INVITATION FOR BIDS

CCK-2568-22
ADDENDUM # 3
09/02/2021

2555.0 Construct/Improve Greek Housing

Addendum #3

DWG. NO.: LH101

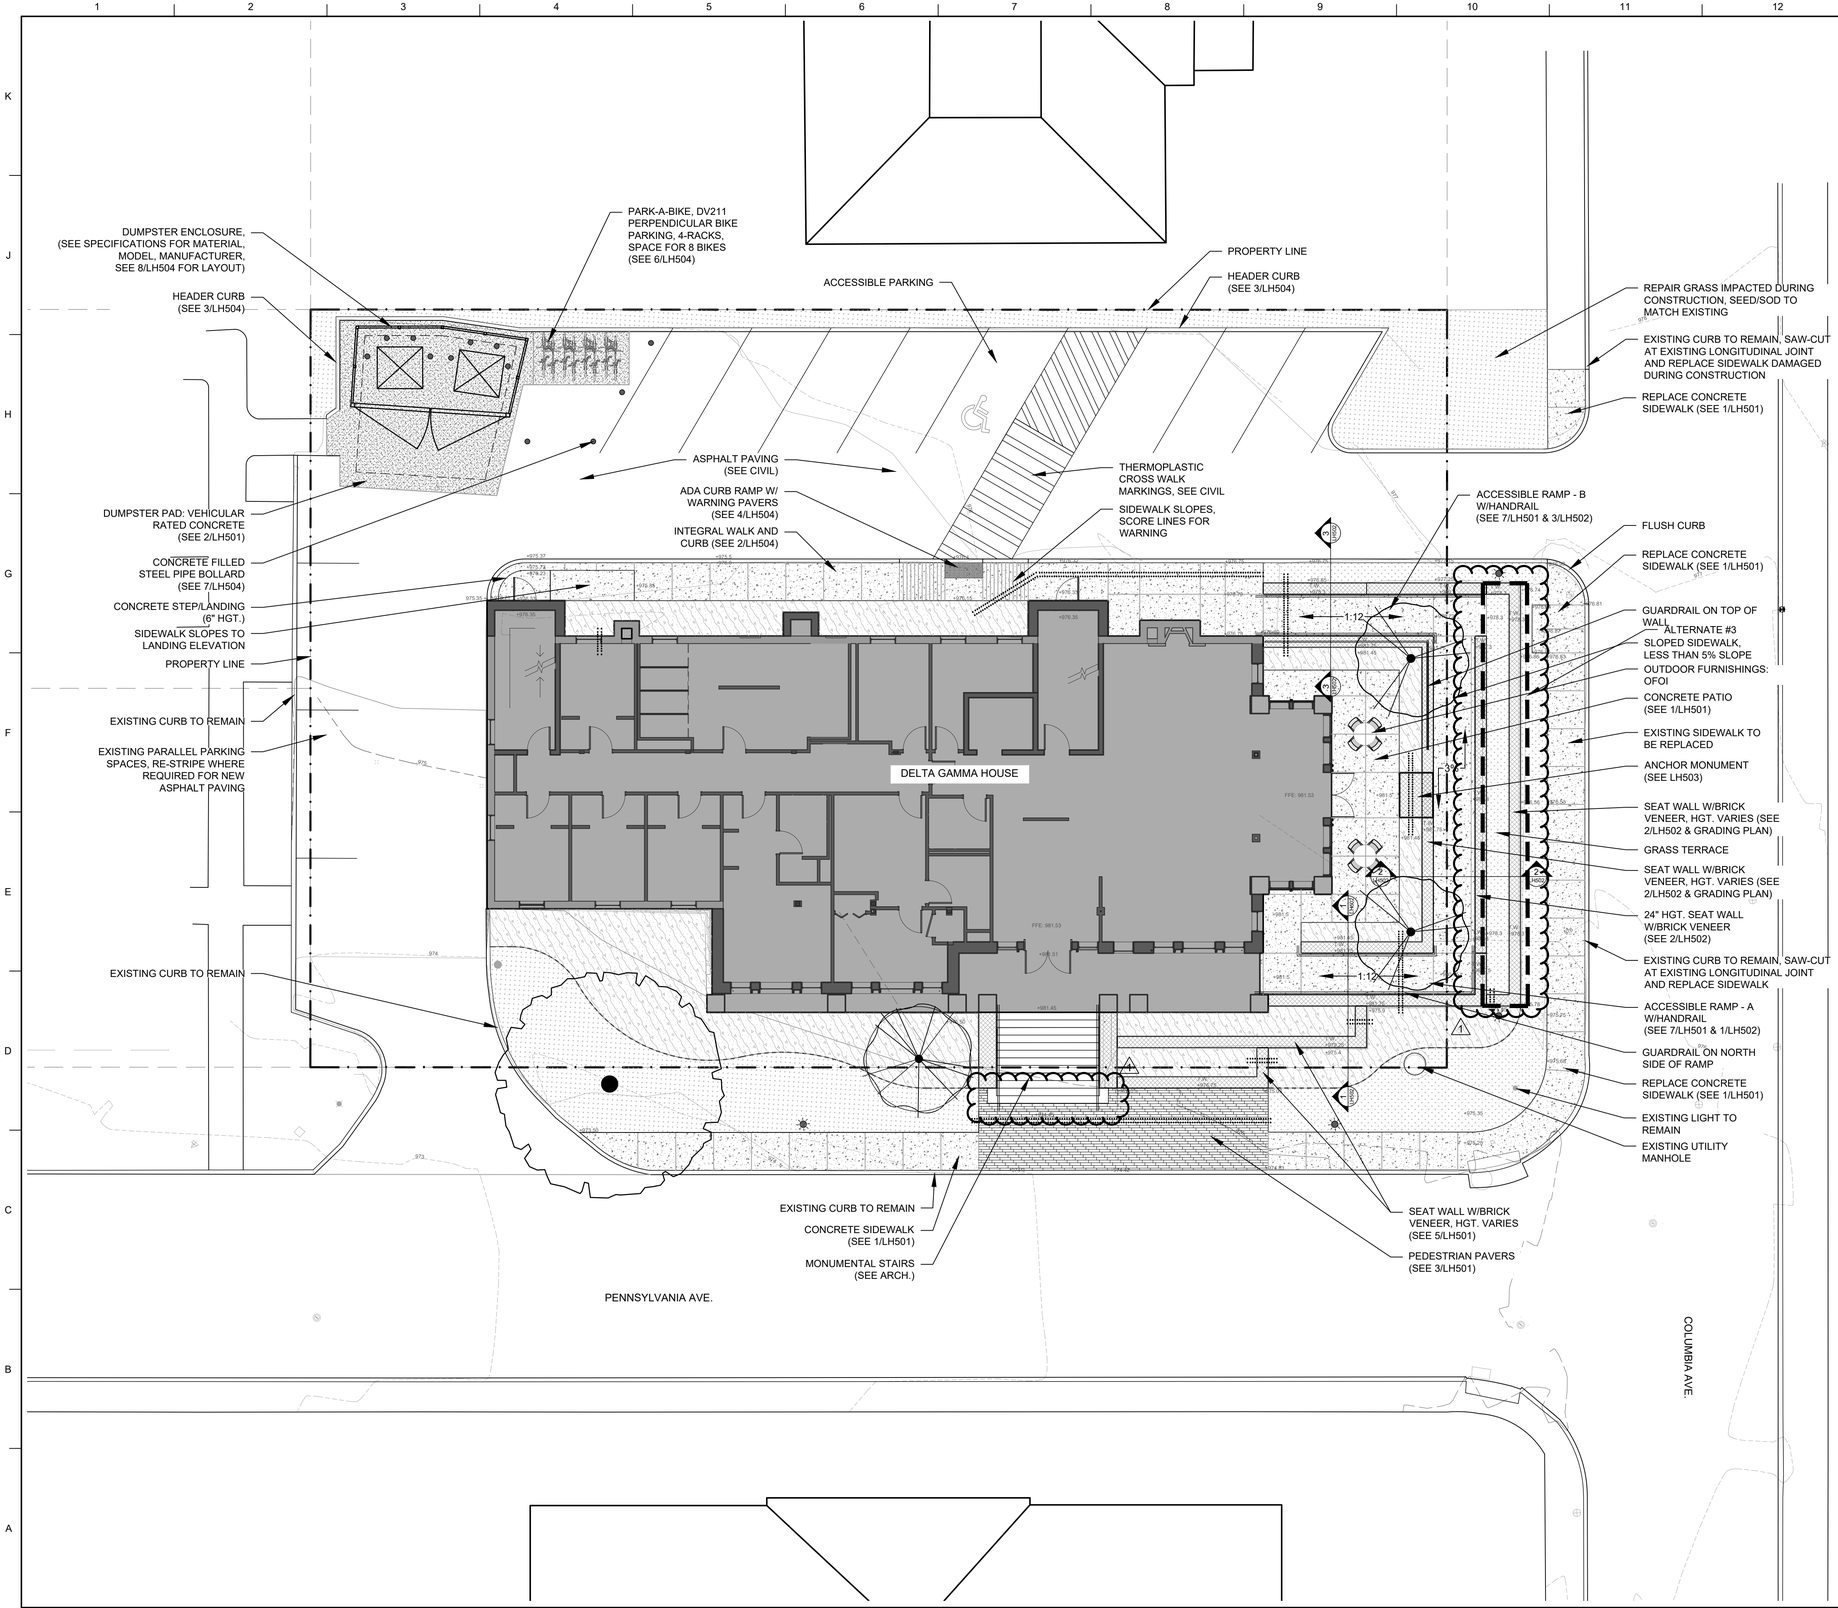
LH101	SITE PLAN	9/1/21

- Bottom of front stair removed
- Alternate #3 added

ISSUE DATE: 08/03/2021
JOB. NO.: 11476-00
DWG. NO.: LH201

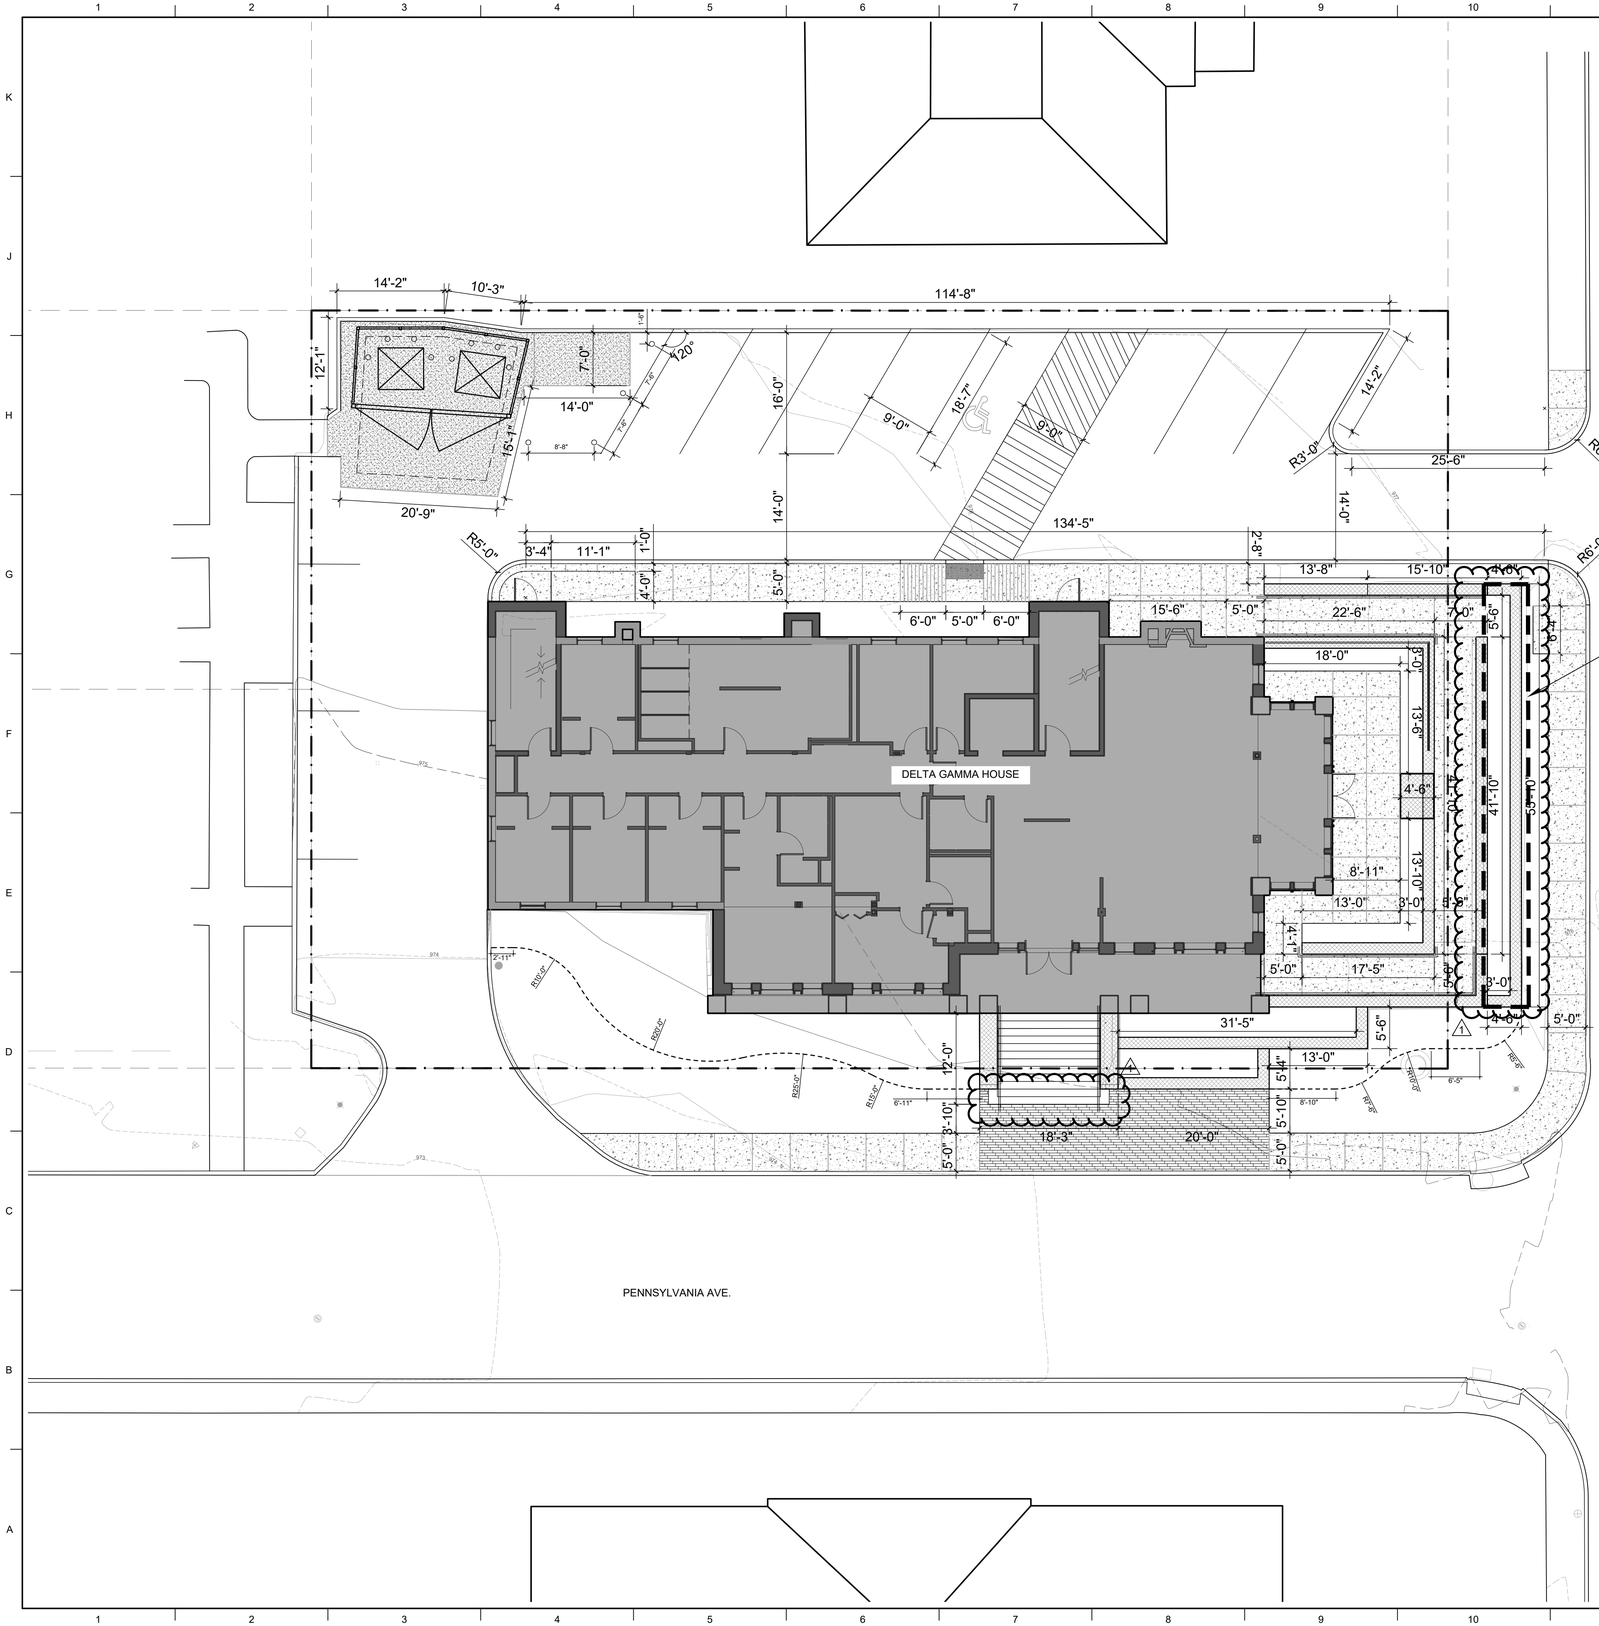
LH201	LAYOUT PLAN	9/1/21

- Bottom of front stair removed
- Alternate #3 added

DWG. NO.: LI101

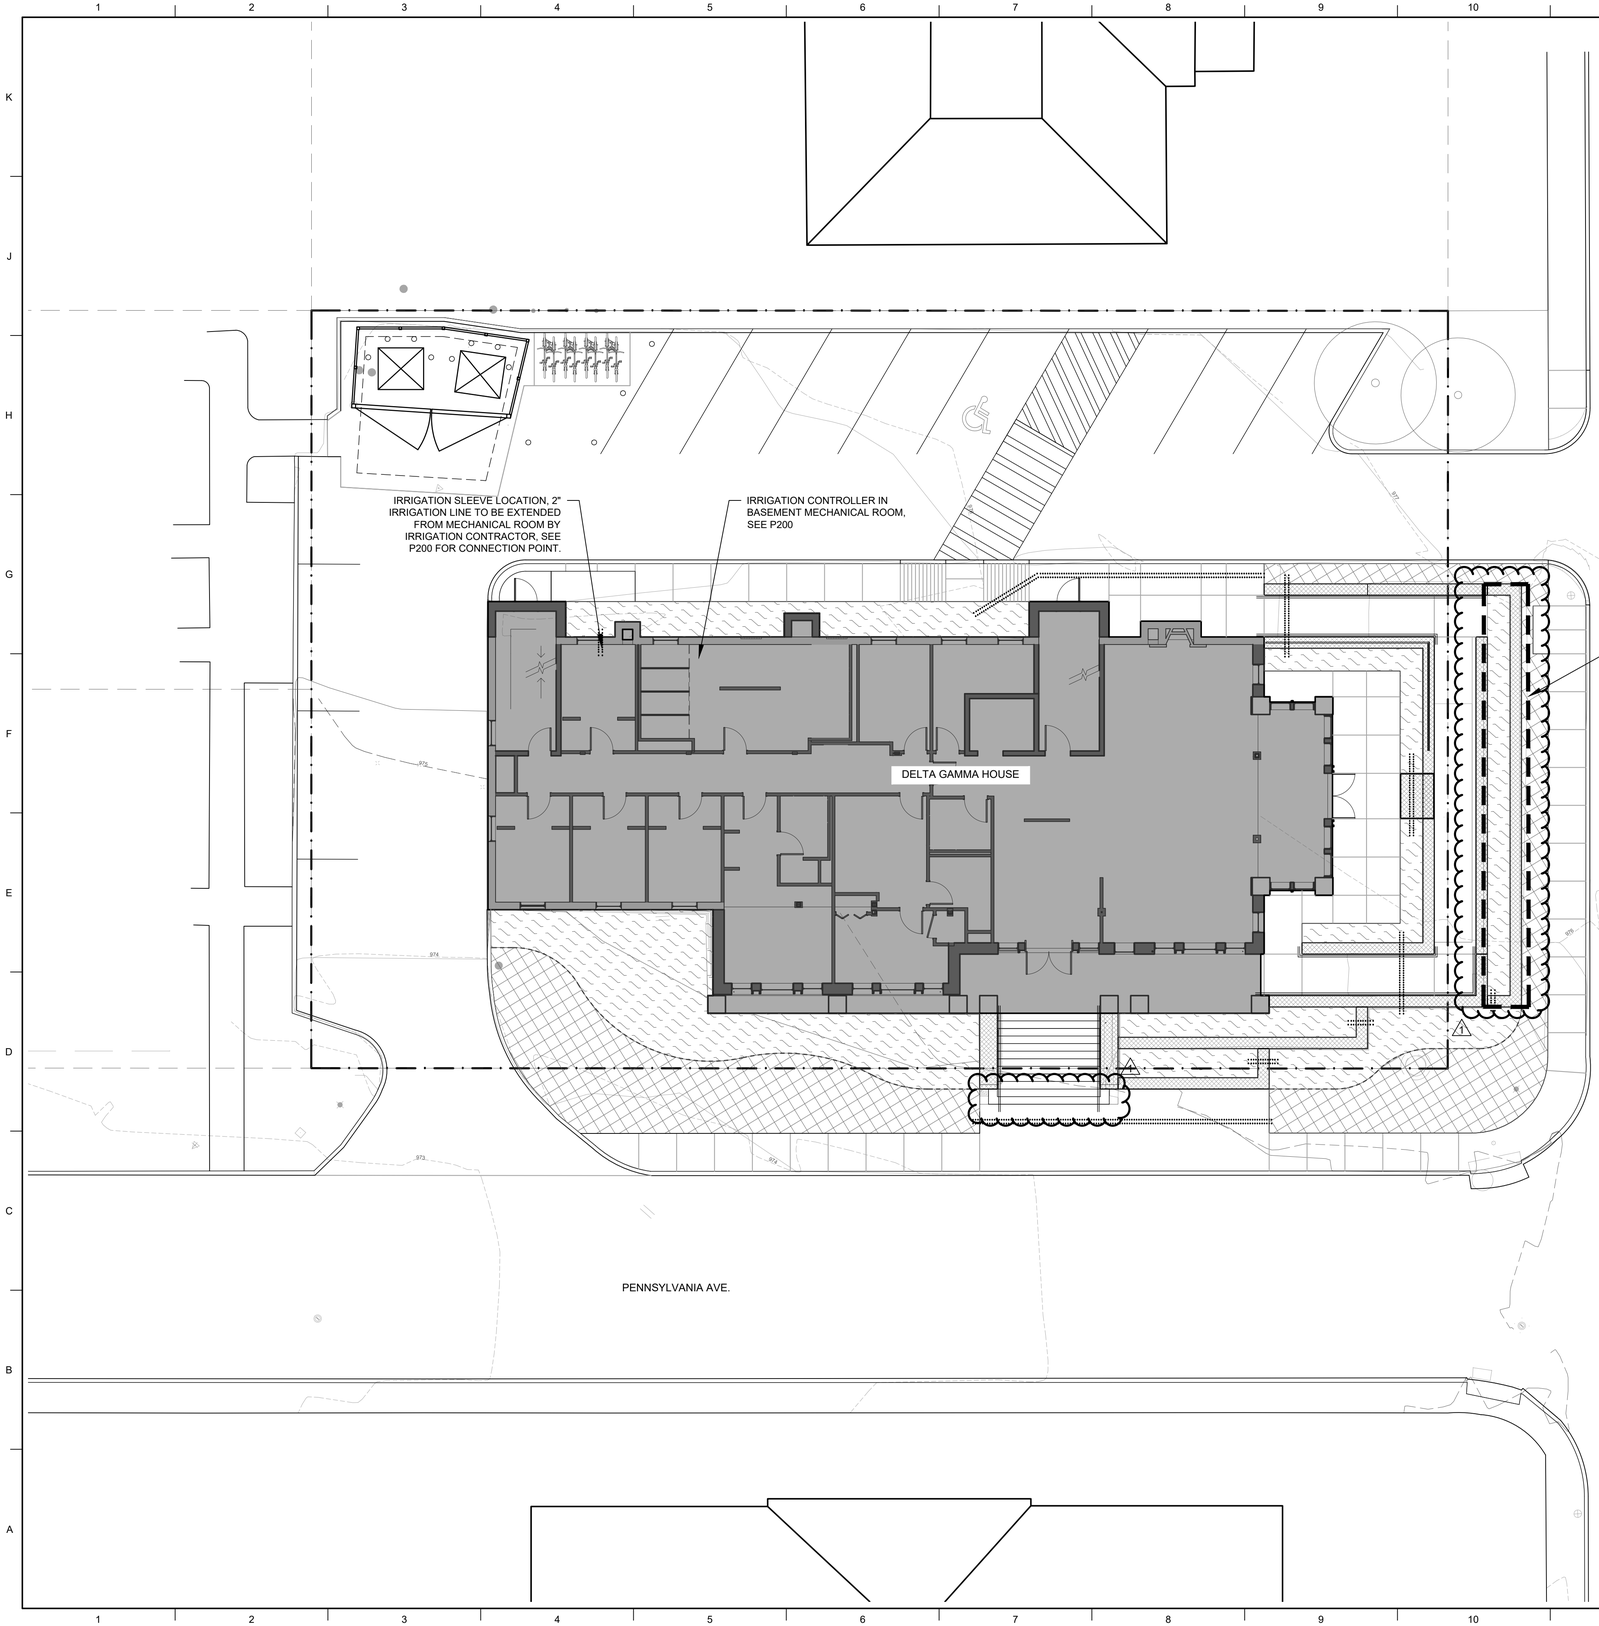
LI101	IRRIGATION AREA PLAN	9/1/21

- Bottom of front stair removed
- Alternate #3 added

DWG. NO.: LP101

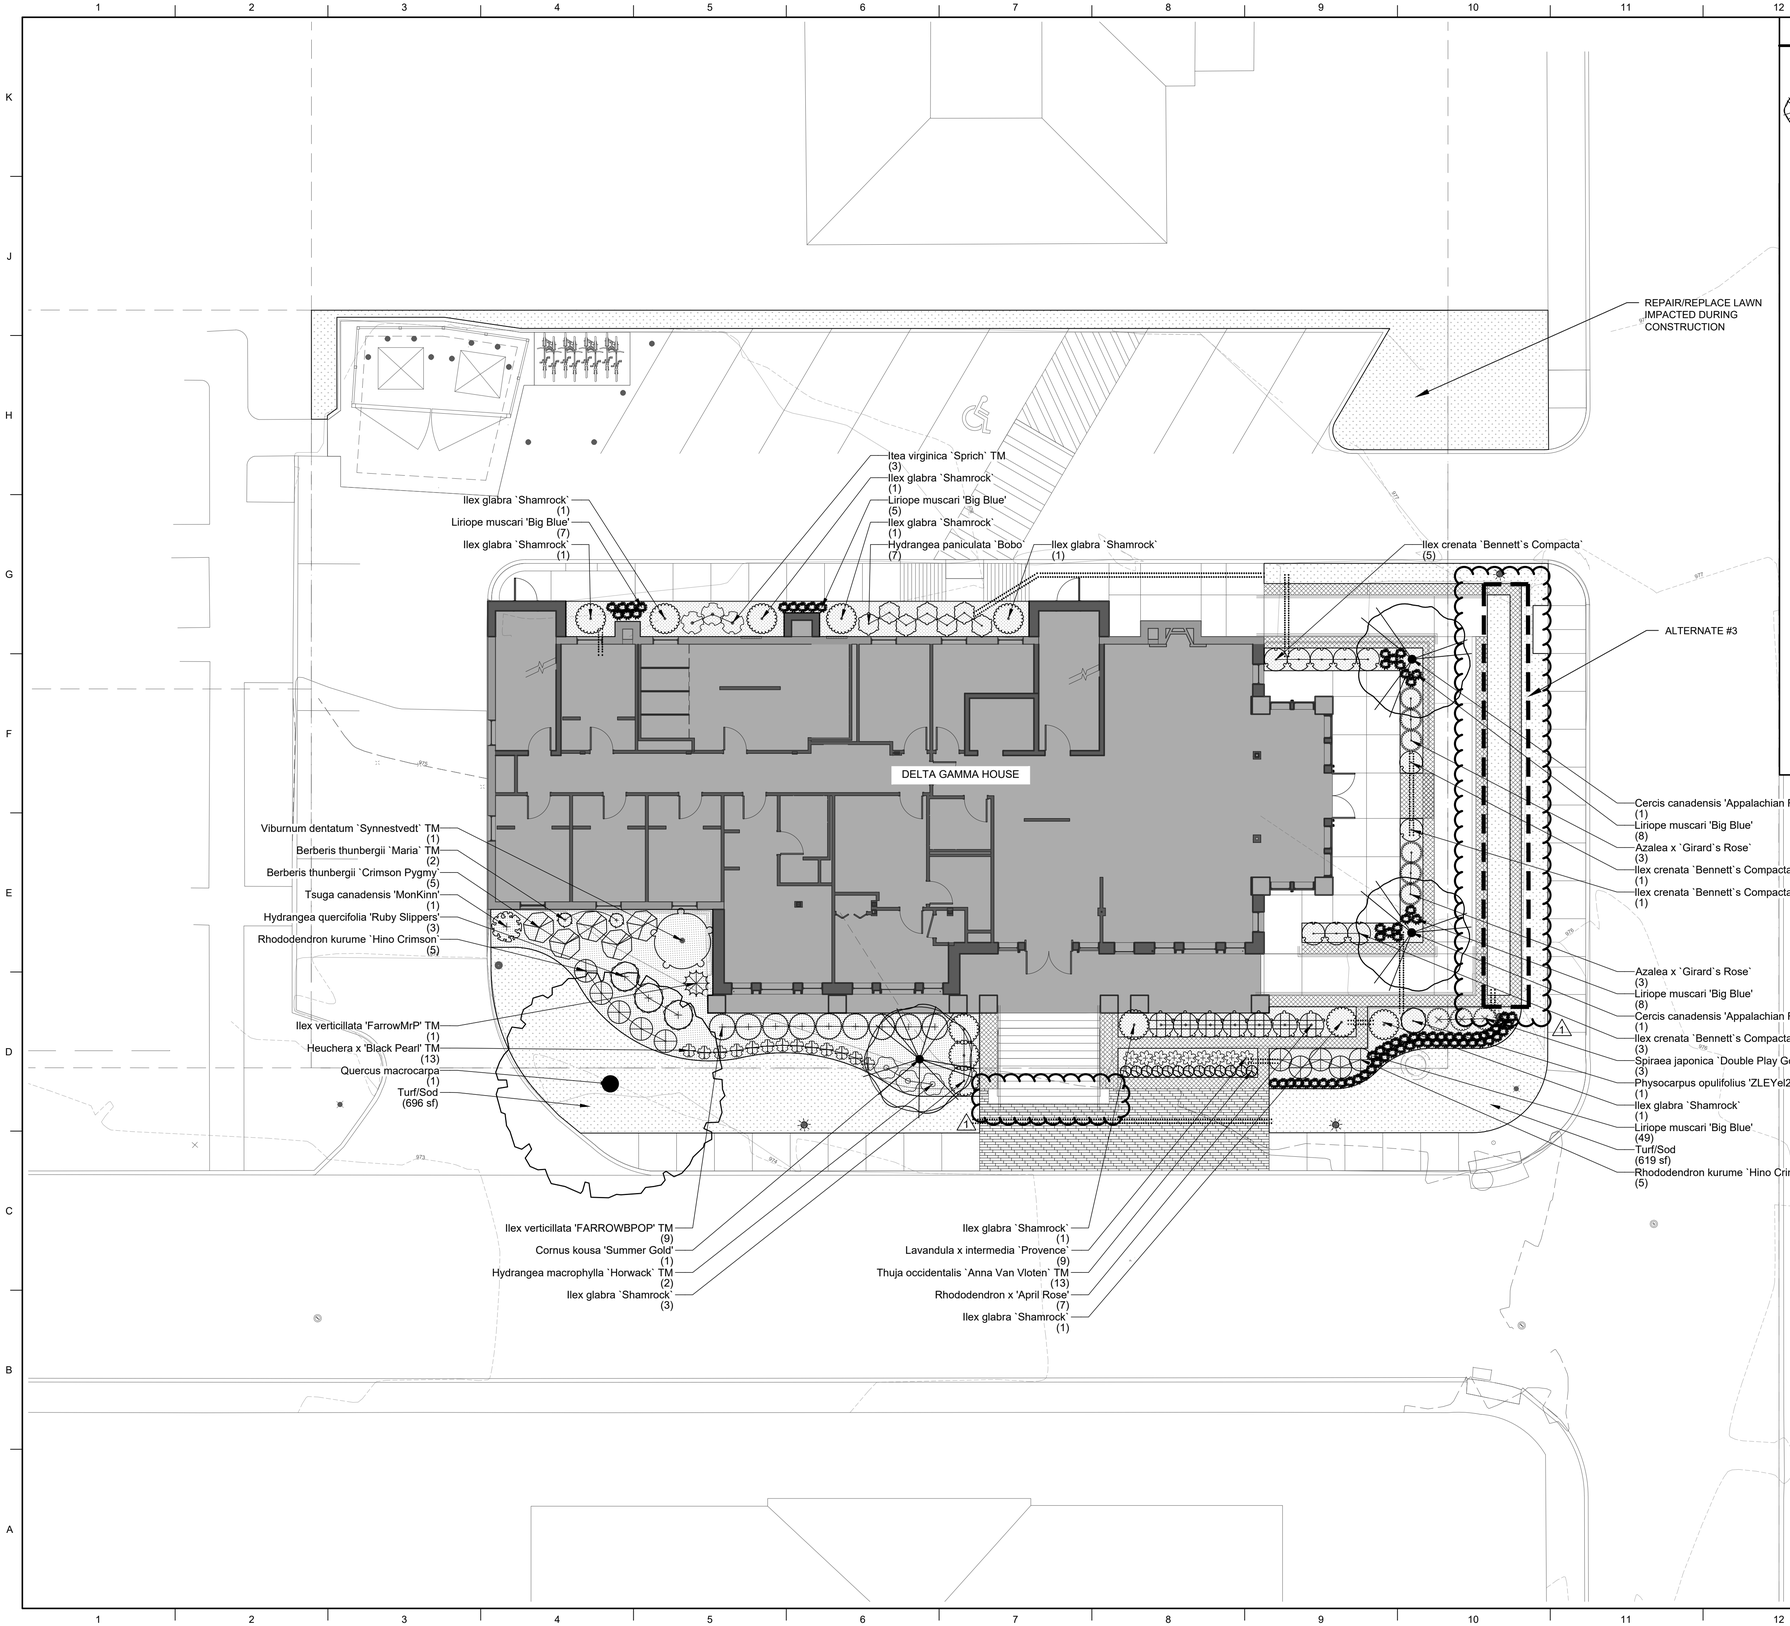
LP101	PLANTING PLAN	9/1/21

- Bottom of front stair removed
- Alternate #3 added
